## Town of Atherton

July 7, 2016

RE: Comments on the Facebook Campus Expansion Project Draft Environmental Impact Report,  
SCH# 2015062056

ATHERTON COMMENTS EXHIBIT 1  
 DERIVED PROJECT AM / PM PEAK HOUR TRAFFIC VOLUMES  
 INTERSECTIONS IN PROJECT VICINITY  
 BACKGROUND (2020) CONDITION

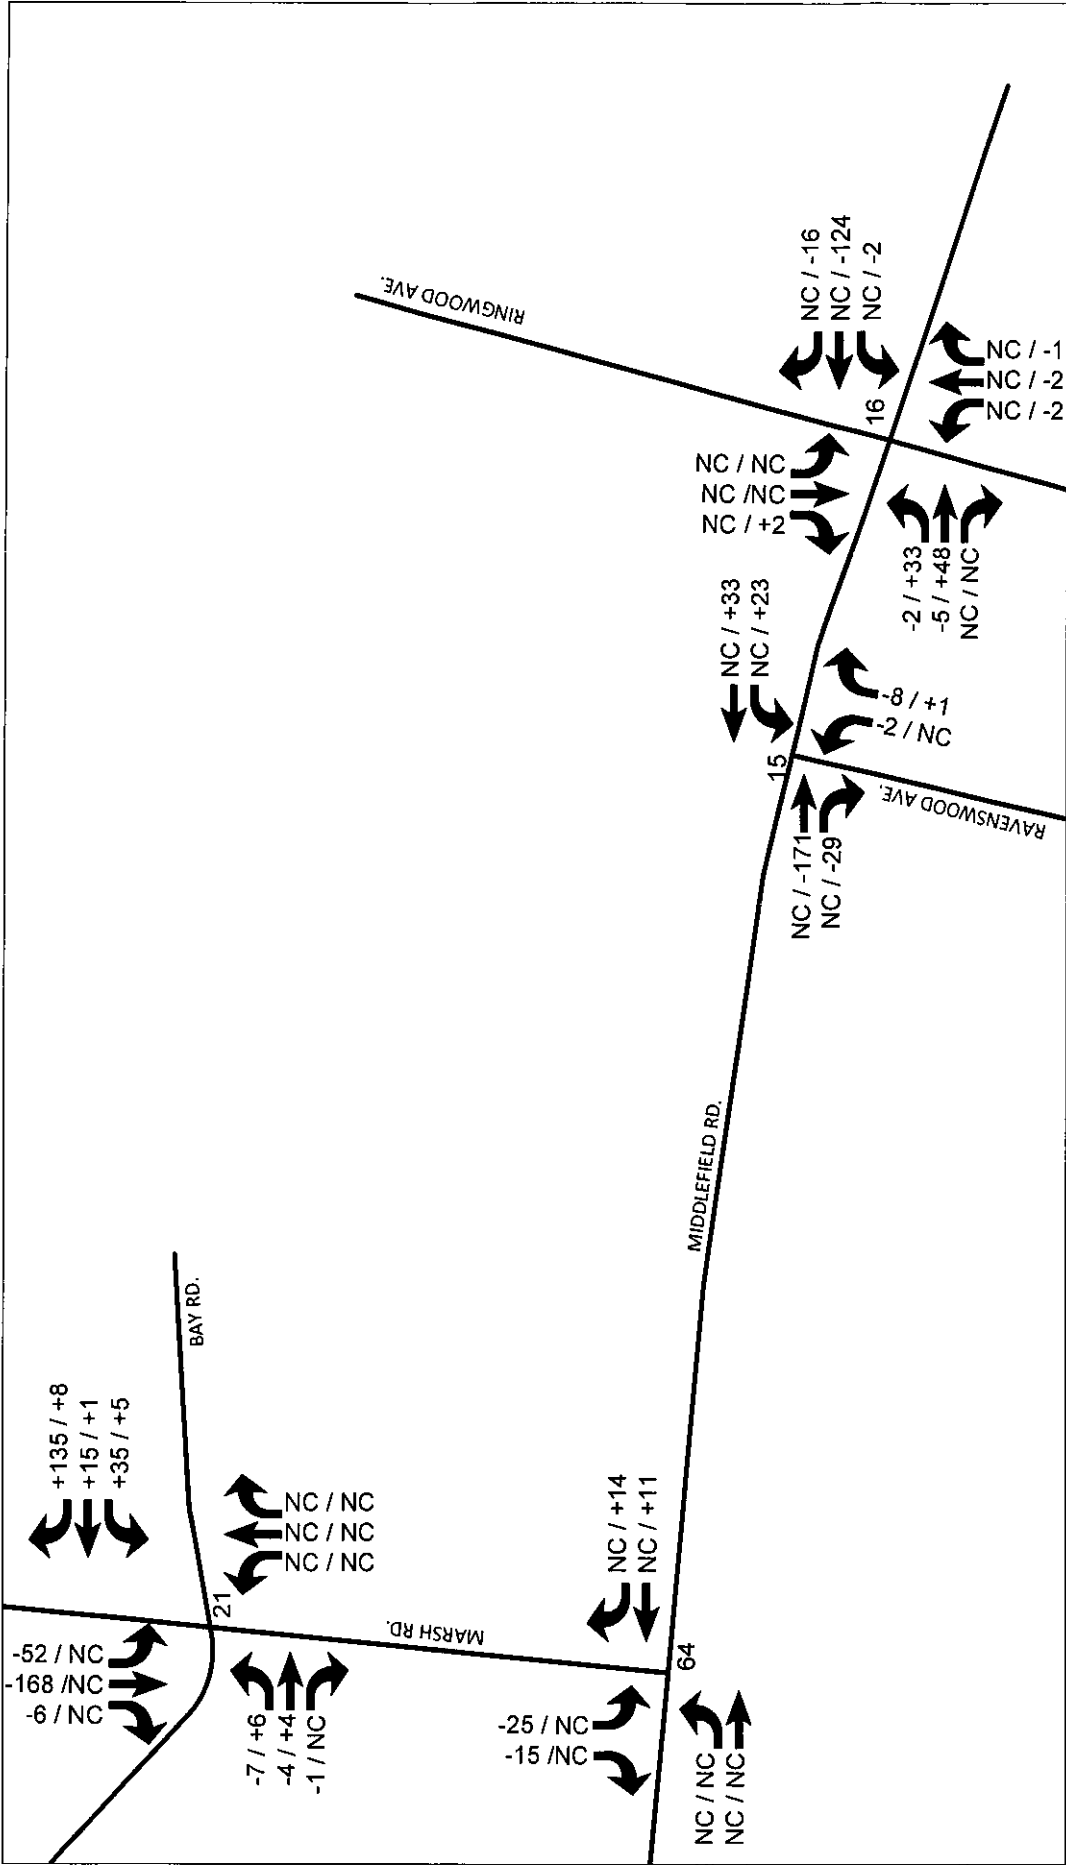
deriving the AM/PM peak hour project volumes from the scenario volumes provided in the appendices by subtracting the Baseline traffic volumes from the Baseline + Project volumes. These derived project traffic volumes are illustrated on the attached Atherton Response Exhibits 1-6, for Background and Cumulative 2040 conditions, for those study intersections that are surrounding the project site and those that are within the Town of Atherton.

A review of Exhibits 1-6 shows that the derived project traffic volumes are frequently negative. Also, a volume at a given intersection may be positive in the AM and negative in the PM, and vice versa. It is understood that having negative numbers is not unusual in the comparison of model-generated volumes, however, some of the negative numbers were in the hundreds of trips. The variations and large negative numbers indicate that there may be issues with the model.

In some cases, a change was shown in turning movements that appeared to be unrelated to the project, for instance, at Chilco/Constitution (#45), changes were shown for northbound left and eastbound right, movements which would not reasonably go to or from the Project site. There was a similar situation at Bayfront Expressway (SR 84)/Willow Road (SR 114) for the southbound left and westbound right movements during the PM peak hour. Were post-processing reasonableness checks performed to ensure that the project volumes made sense?

A comparison of the derived Project traffic volumes on the Atherton Response Exhibits 1-6 also shows a large difference in the derived Project traffic volumes under Background conditions versus Cumulative 2040 conditions. The Project volumes should be very similar, if not the same, for the two scenarios. The Project volumes using the existing driveway on Chilco Street are mostly the same, however, the Project volumes on Bayfront Expressway (SR 84) were quite different. The differences are shown in the table below. Since the study did not provide the without-project driveway volumes for the Bldg 20 Entrance, the Project traffic volumes for the Bldg 21 Entrance cannot be derived. Instead, the approach and departure volumes on Bayfront Expressway on either side of the two Facebook driveways were reviewed. The approach and departure volumes are based on the derived Project volumes at the adjacent intersections at Chilco Street and at Willow Road (SR 114).
